Re: Wygate Park, Spalding - Emergency Link

EMERGENCY LINK - WOOLRAM WYGATE

DESCRIPTION: Associated landscape to emergency link/footway/
cycleway between the site and Woolram Wygate

LOCATION: Land west of Woolram Wygate, Spalding.

EMERGENCY ACCESS - NORMAN WHITE

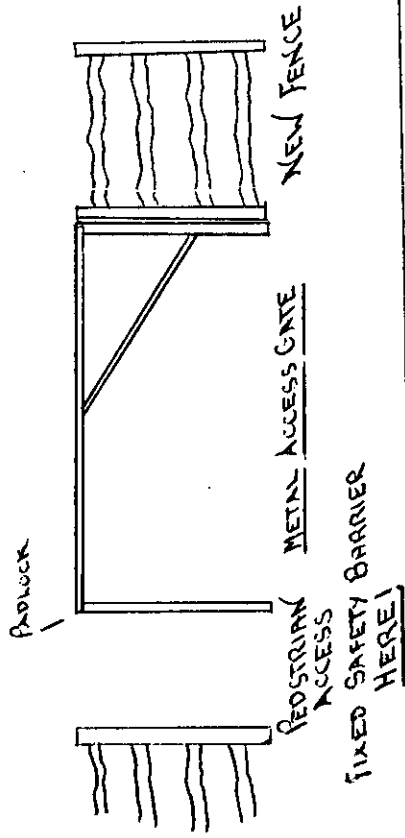
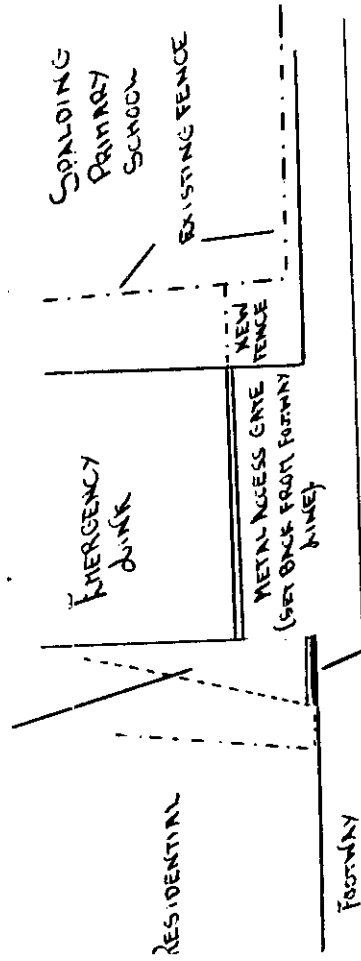
MINOR REALIGNMENT OF HARD SURFACE

FIXED SAFETY BARRIER
